Project	IEEE 802.16 Broadband Wireless A	Access Working Group <a href="http://ieee802.org/16">http://ieee802.org/16</a> >		
Title	Suggested Modifications for AK Caching			
Date Submitted	September 22, 2006			
Source(s)	Joe Schumacher, Steve Upp, Walter Goulet Motorola	Voice: +1 847 632 5978 [mailto:j.schumacher@motorola.com]		
	Simon Mizikovsky, Robert Rance, Dan Gal, Peretz Feder Lucent Technologies	Voice: +1 973 386 6348 [mailto:smizikovsky@lucent.com]		
	Phillip Barber Huawei, Inc	Voice: +1 972 365 6314 [mailto: pbarber@huawei.com]		
Re:	802.16 Corrigendum 2			
Abstract	Modifications are proposed that support the proposed AK Caching Solution without discarding the legacy CMAC calculation mode.			
Purpose	Adoption			
Notice	This document has been prepared to assist IEEE 802.16. It is offered as a basis for discussion and is not binding on the contributing individual(s) or organization(s). The material in this document is subject to change in form and content after further study. The contributor(s) reserve(s) the right to add, amend or withdraw material contained herein.

## **AK Caching Solution**

Figure 130o—HMAC/CMAC/KEK derivation from AK

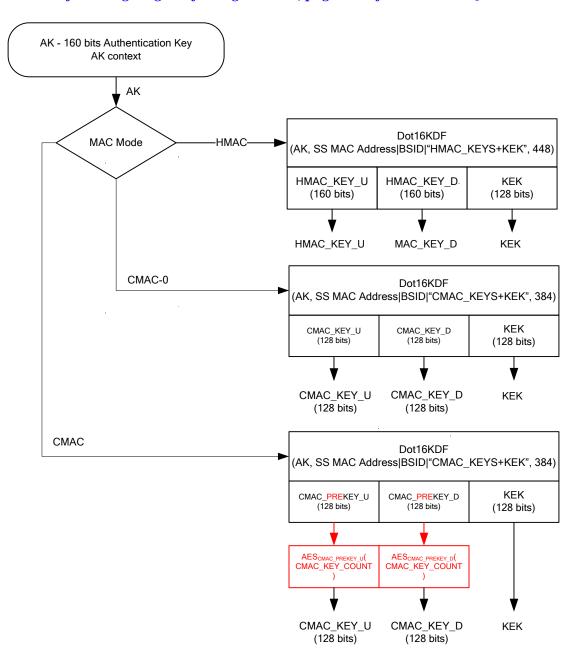
## **Change 6: Modify CMAC Key derivation figure.**

[Please substitute the following diagram for Figure 1300, page 283 of 802.16e-2005]
